CITY OF ALBUQUERQUE

RE: **2440 Louisiana NE**
Grading and Drainage Plan
Engineer's Stamp Date: 9/25/19
Hydrology File: H19D084

Re: 2440 Louisiana - Hydrology File: H19D084
COA Hydrology Building Permit Approval Re-Submittal

2440 LOUISIANA
DRAINAGE MANAGEMENT PLAN

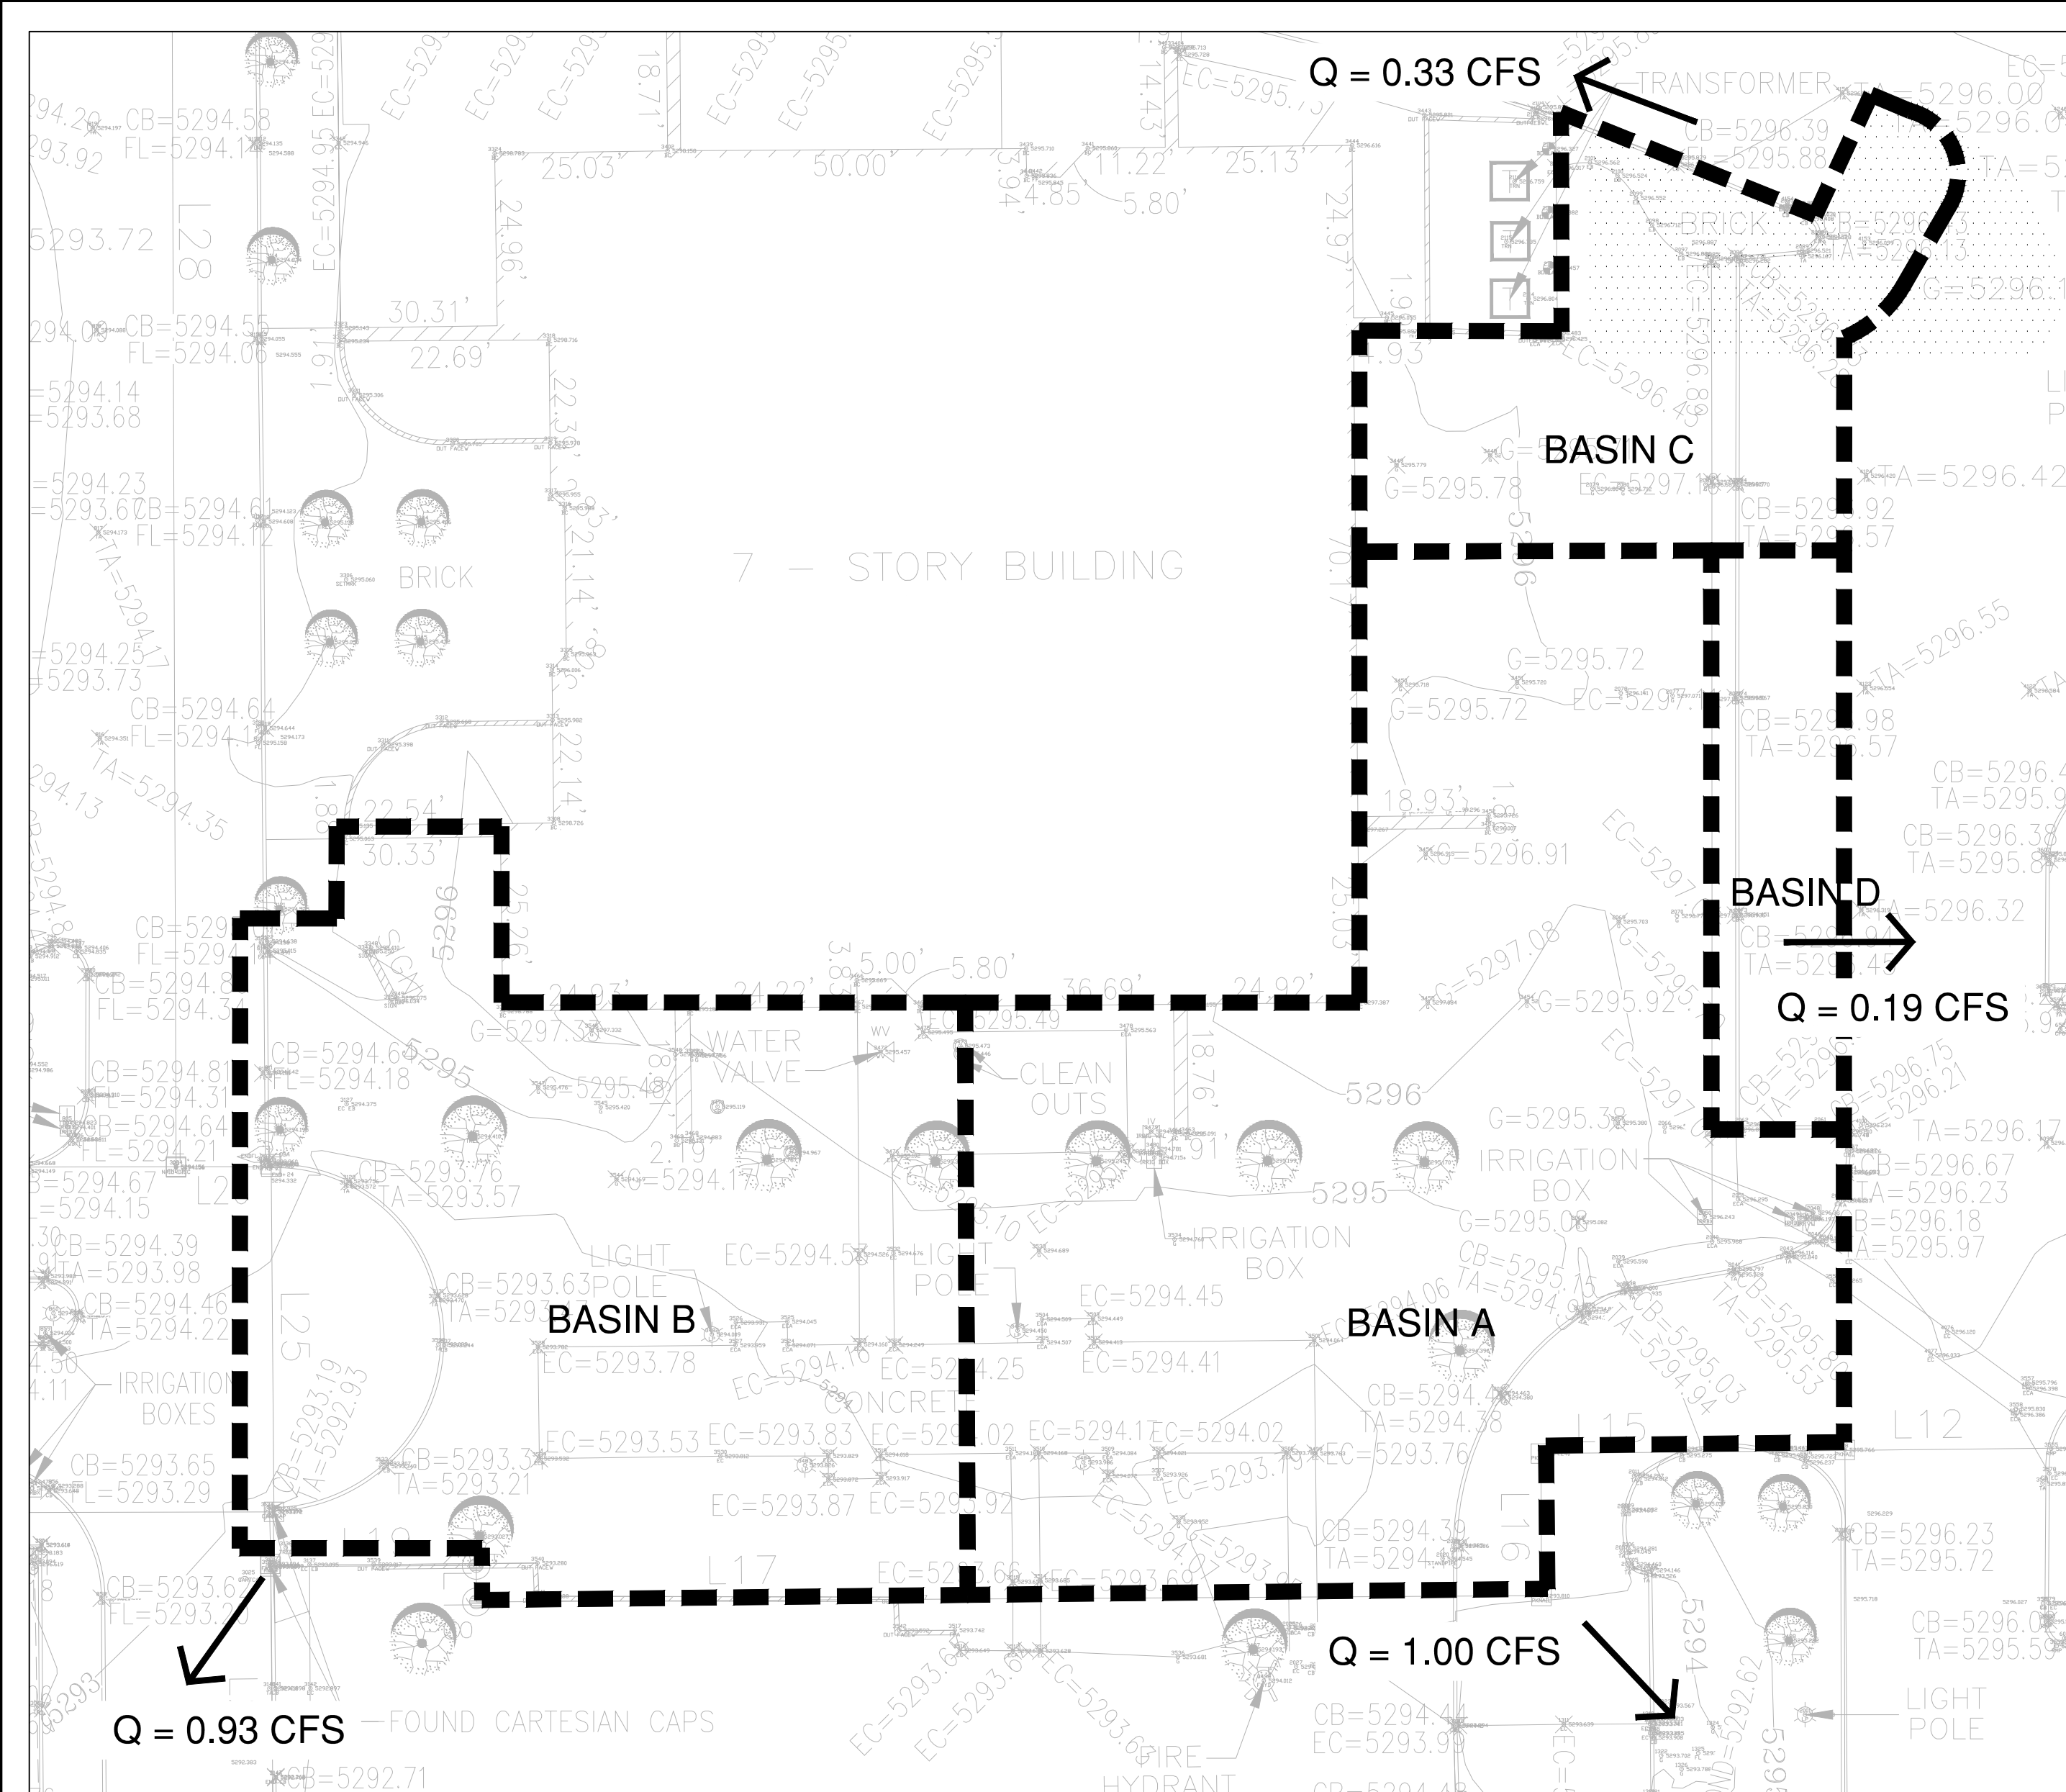
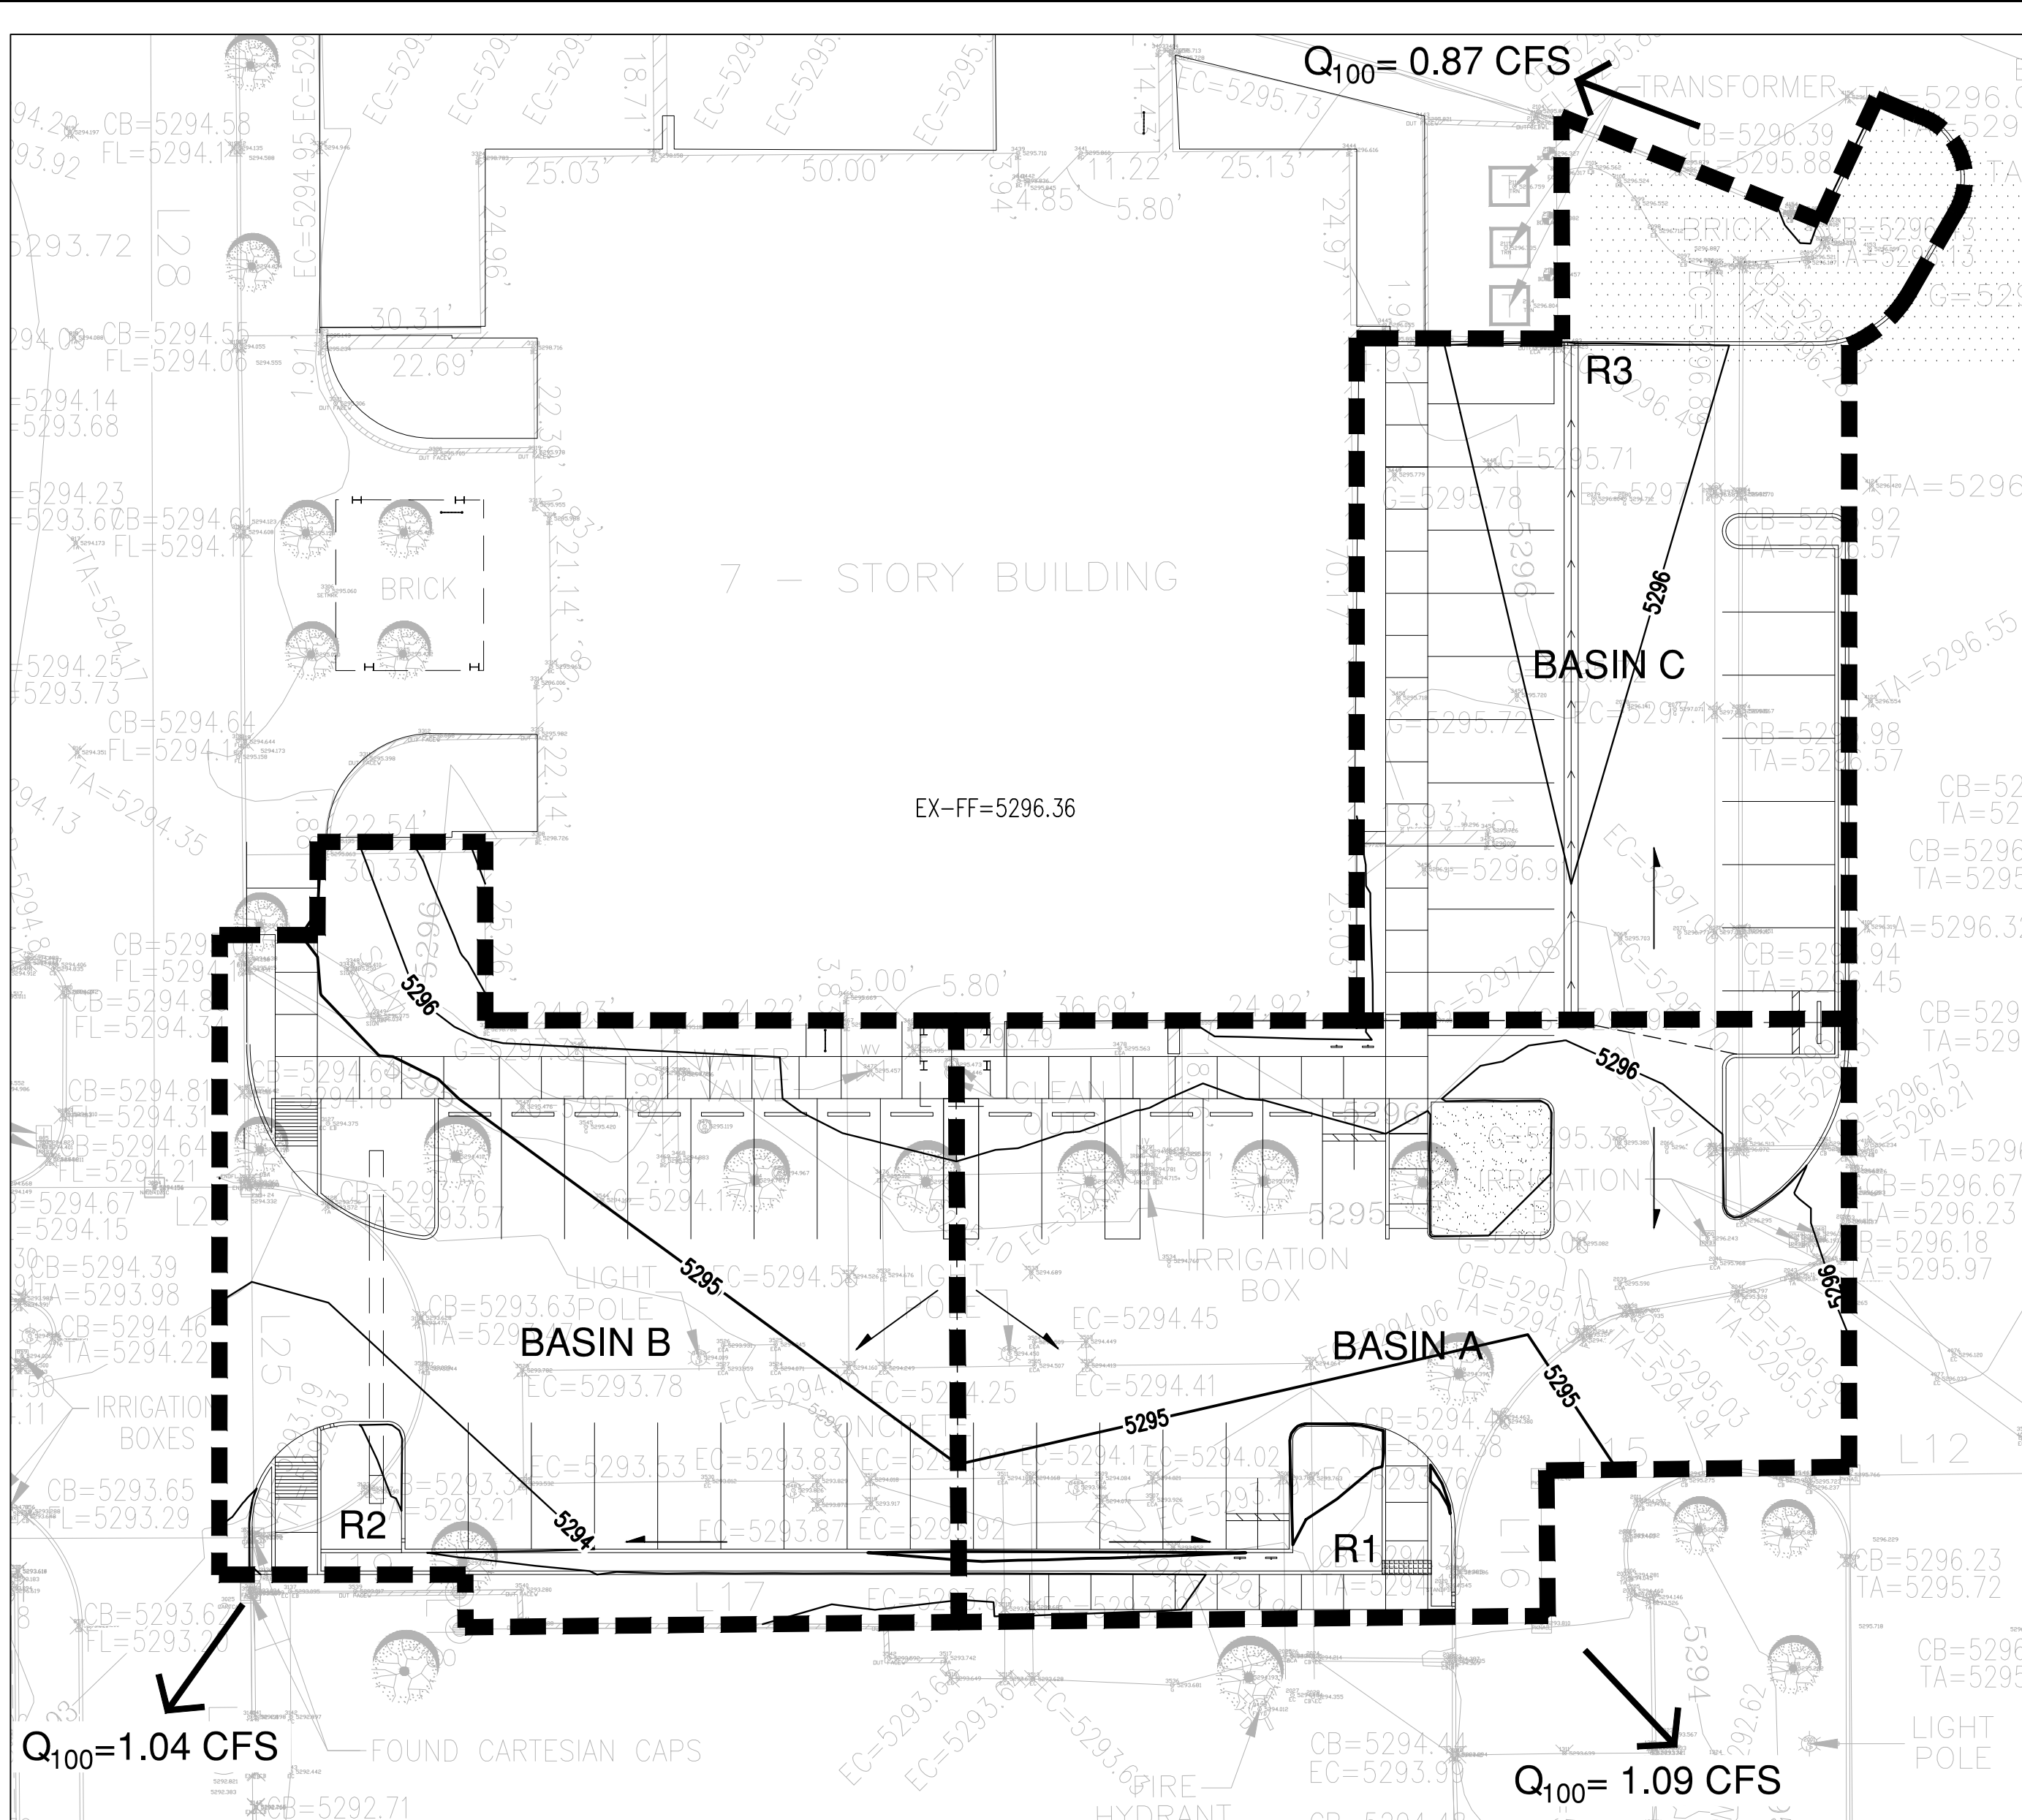
2. Provide two detailed and scaled exhibits of the land treatments; one for existing and one for proposed. Delineate between areas of impervious and pervious cover on both and provide the area take-offs.

Response: Two viewports are now provided for both the existing conditions and proposed conditions. Associated drainage tables are now provided for both conditions as well. Associated runoff flow rates and volumes are shown.

1. The orifice plates on inlets 2 and 3 in the NW parking lot (outfall for proposed basin C) are missing and need to be replaced in order for the parking lot detention pond to function as proposed. Include this repair/replacement work on the plan. The orifice plates for the SW parking lot (outfall for basin B) were recently replaced and the pond near the parking garage entrance is still in place, so those outfalls are acceptable.
2. Payment in Lieu (Amount = $482\text{CF} \times \$8/\text{CF} = \3856 , per sheet C-001) of onsite management of the SWQV must be made. Take three copies of the treasury deposit slip to the Treasury and then include one copy of the paid deposit slip when resubmitting.
3. Because these corrections are minor, the administrative resubmittal fee of \$40 may be used. Please include a copy of this letter when resubmitting in order to receive the reduced fee.
